File		
AUV Dock Subsea Housing Electronics		
Size	Document Number	Rev
D	10020821	C
Date:	Monday, May 15, 2023	Sheet 1 of 1

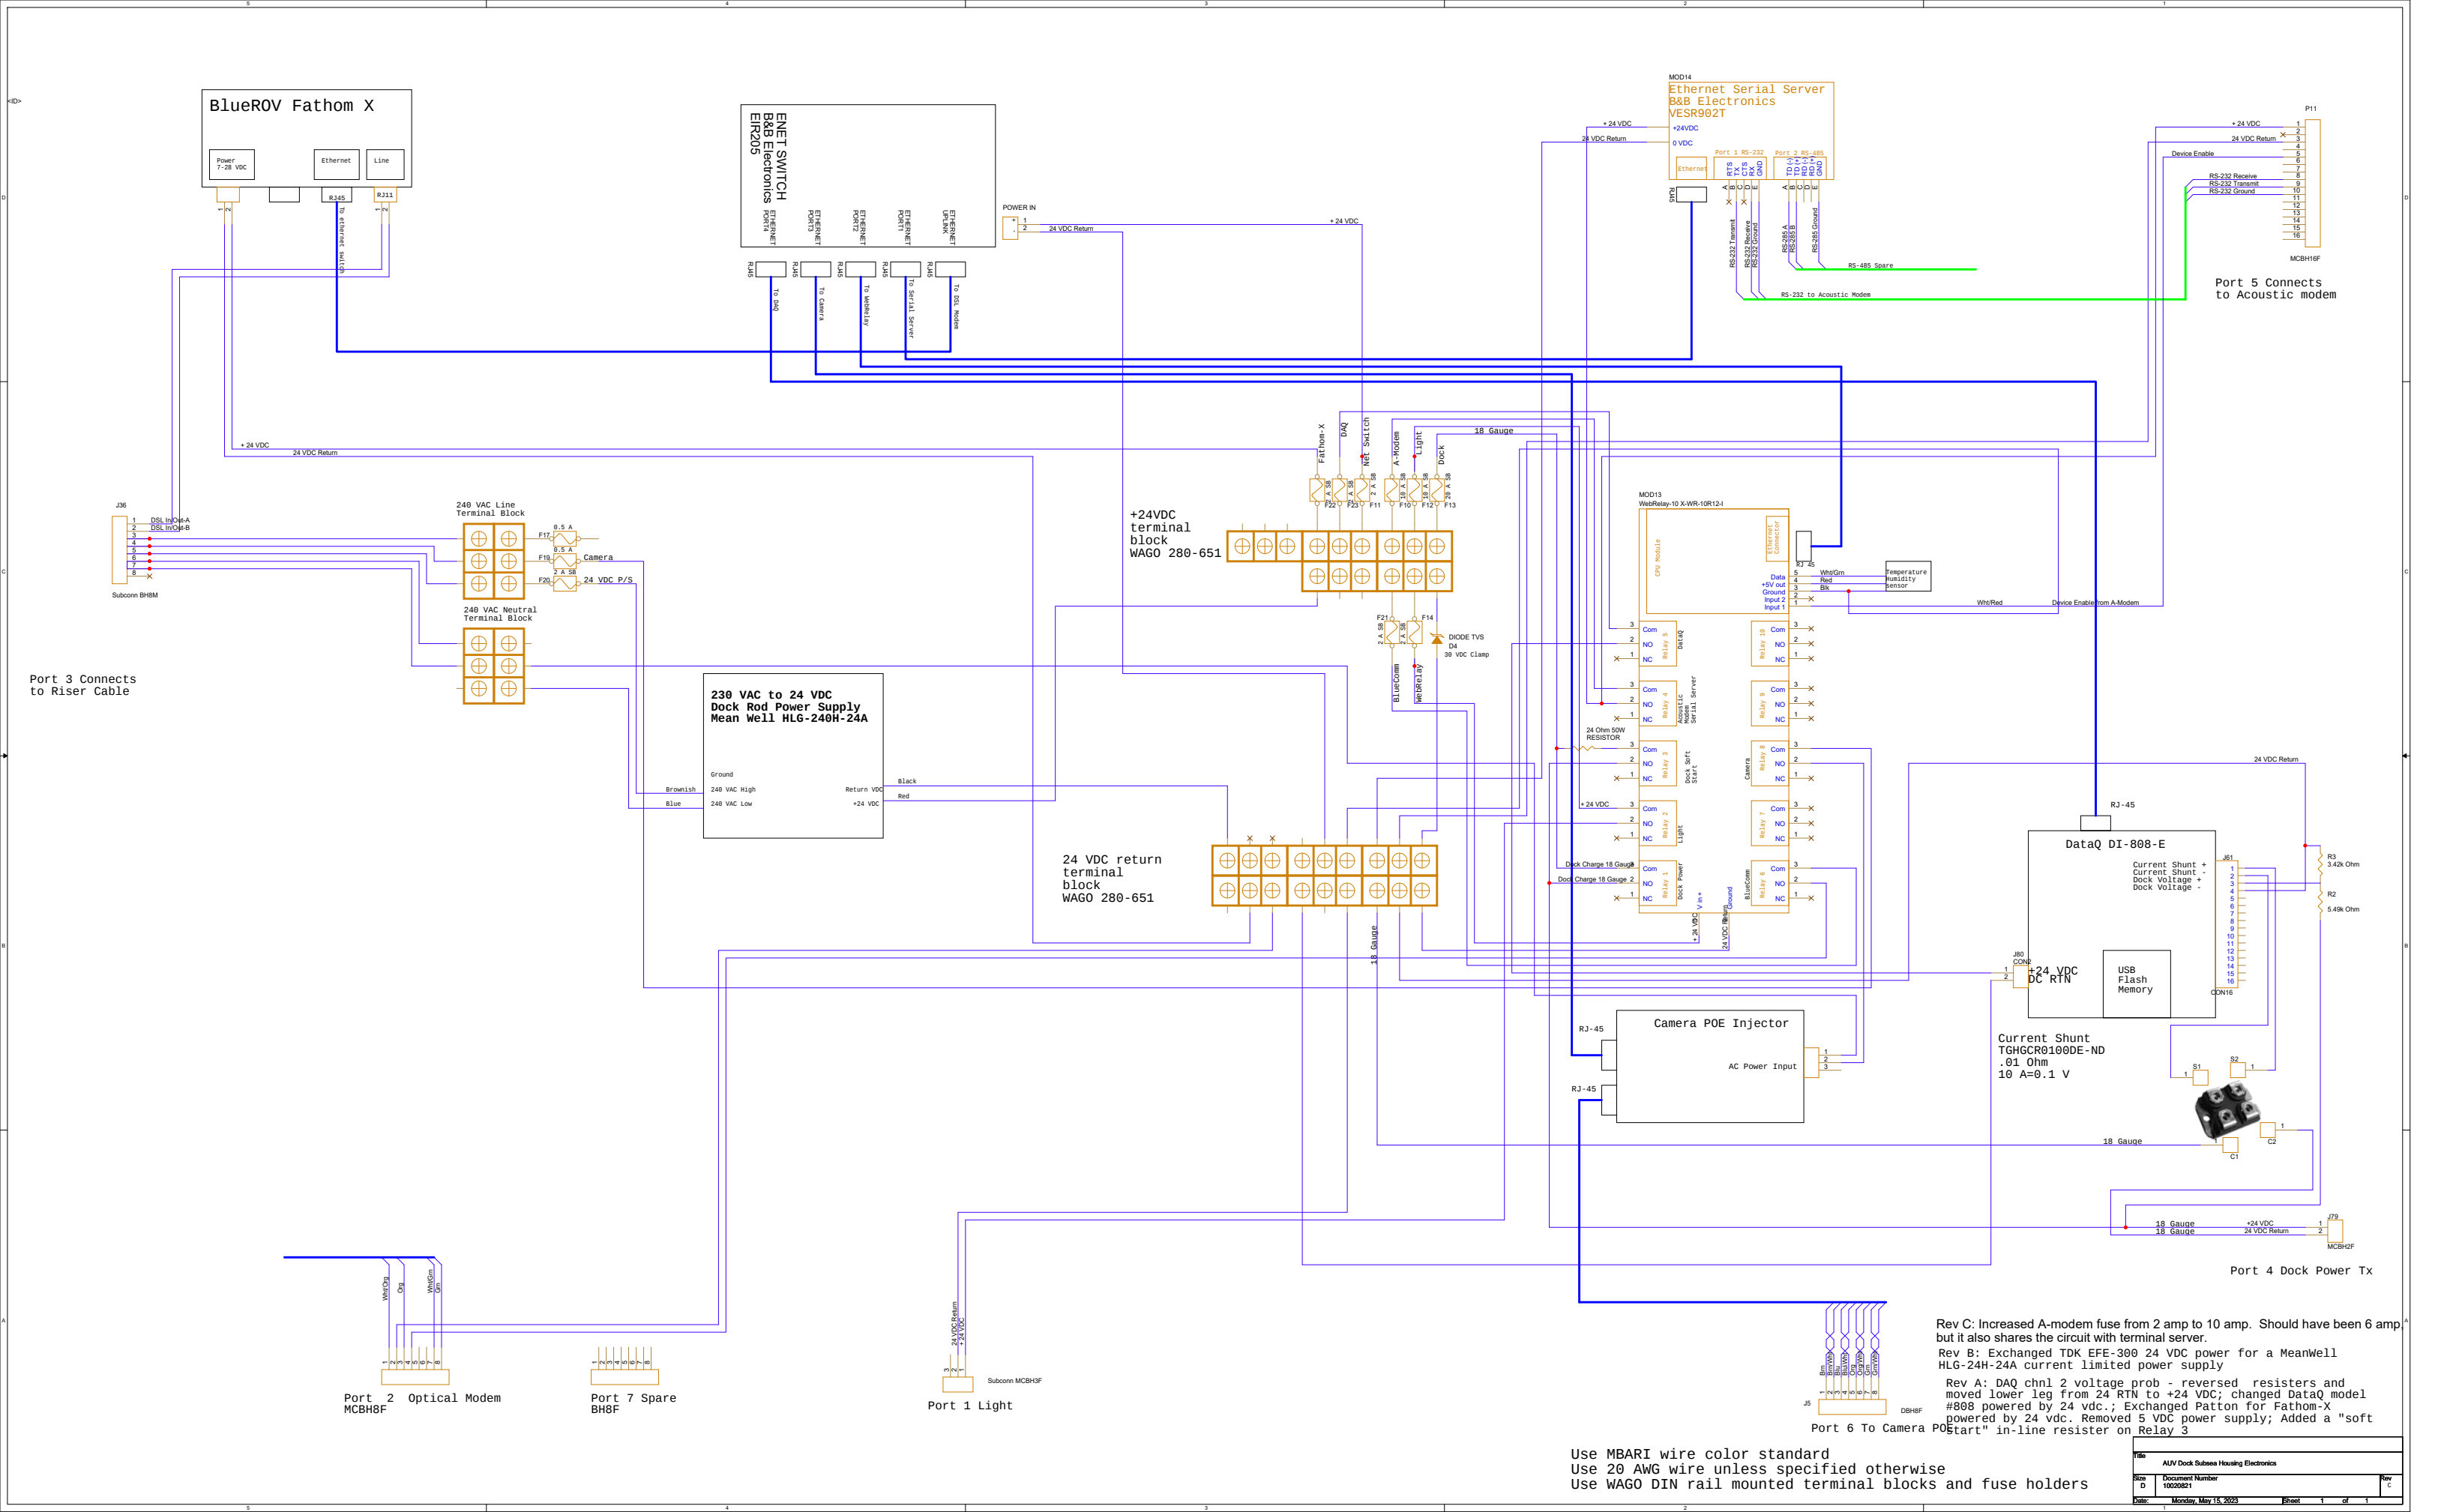
Rev C: Increased A-modem fuse from 2 amp to 10 amp. Should have been 6 amp but it also shares the circuit with terminal server.
Rev B: Exchanged TDK EFE-300 24 VDC power for a MeanWell HLG-24H-24A current limited power supply
Rev A: DAQ chnl 2 voltage prob - reversed resistors and moved lower leg from 24 RTN to +24 VDC; changed DataQ model #808 powered by 24 vdc.; Exchanged Patton for Fathom-X powered by 24 vdc. Removed 5 VDC power supply; Added a "soft start" in-line resistor on Relay 3
